DEVELOPMENT REVIEW BOARD REPORT

CASE NUMBER/ **109-DR-2004**
PROJECT NAME **Paradise Valley Arsenic Removal Facility & Administrative Building**
LOCATION **6215 N Miller Rd**

REQUEST Request site plan and elevations approval for an arsenic removal facility.

Paradise Valley Arsenic Removal Facility
CIVIL
OVERALL
SITE PLAN

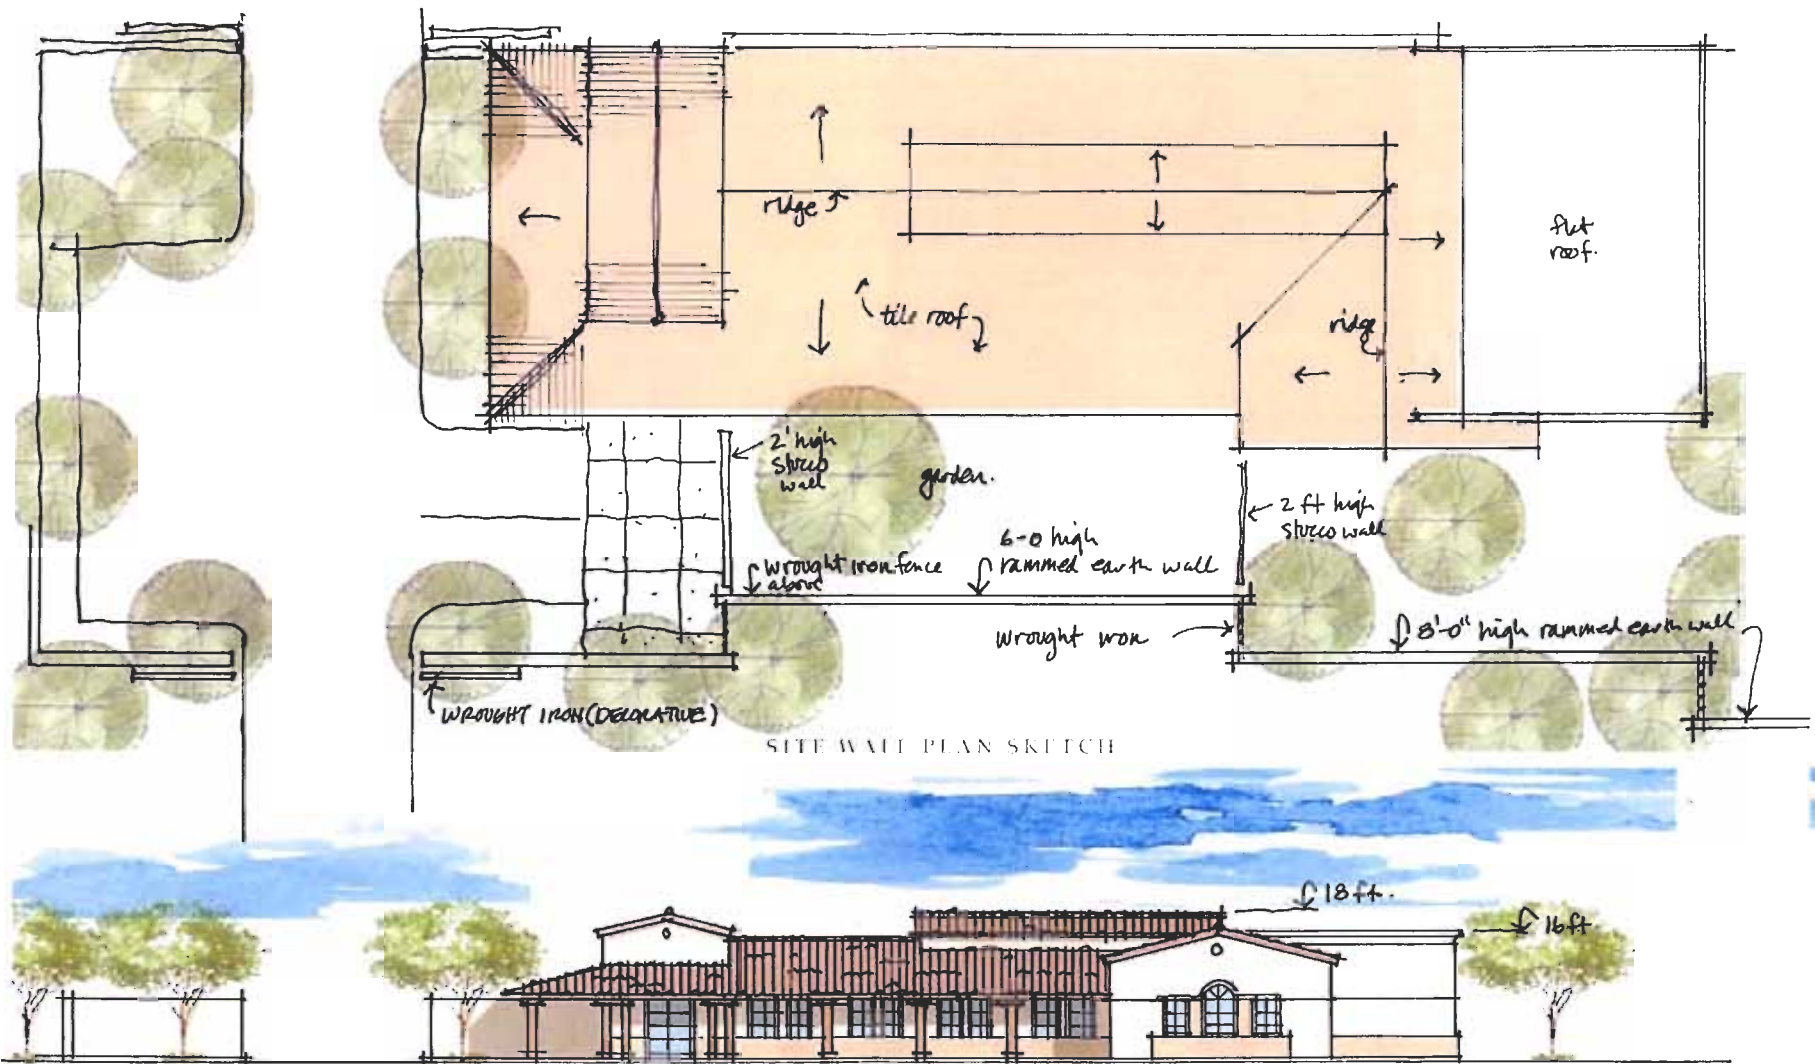
8. All new walls surrounding the site shall be rammed earth with wrought iron accents as shown on the site and landscape plan.
9. No chain link, barbed wire, or other security wire fencing shall be visible to the public or from an off-site location.

11. Dedicate and improve a 15-foot wide public trail easement running east/west along the northern portion of the site connecting Cattletrack with the Arizona Canal. The easement shall encompass the 5-foot wide trail shown on the site and landscape plan. Trails shall be improved with soil lock, stabilized decomposed granite, or other hard surface.

Paradise Valley Arsenic Removal Facility
BACKWASH CLARIFIER
ELEVATIONS

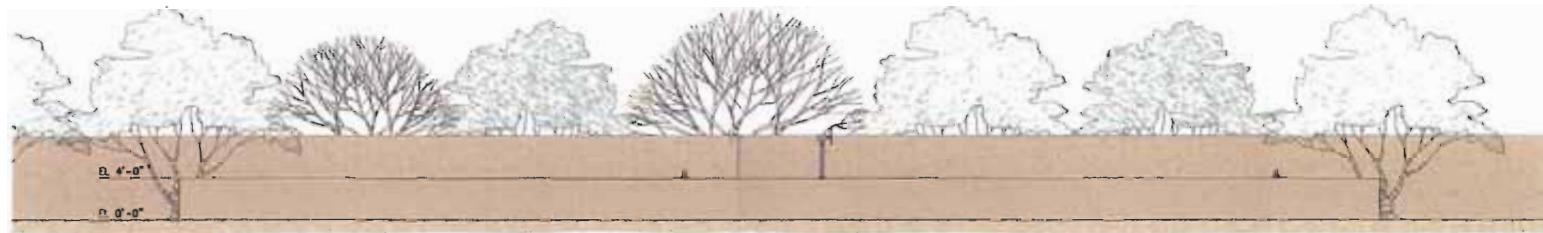
2. Storage tanks shall be painted a brown color.
3. All exterior mechanical, utility, and communications equipment shall be screened by parapet or wall that matches the architectural color and finish of the building. Wall or parapet height for roof-mounted units shall meet or exceed the height of the tallest unit. Wall height for ground-mounted units shall be a minimum of 1' higher than the tallest unit.
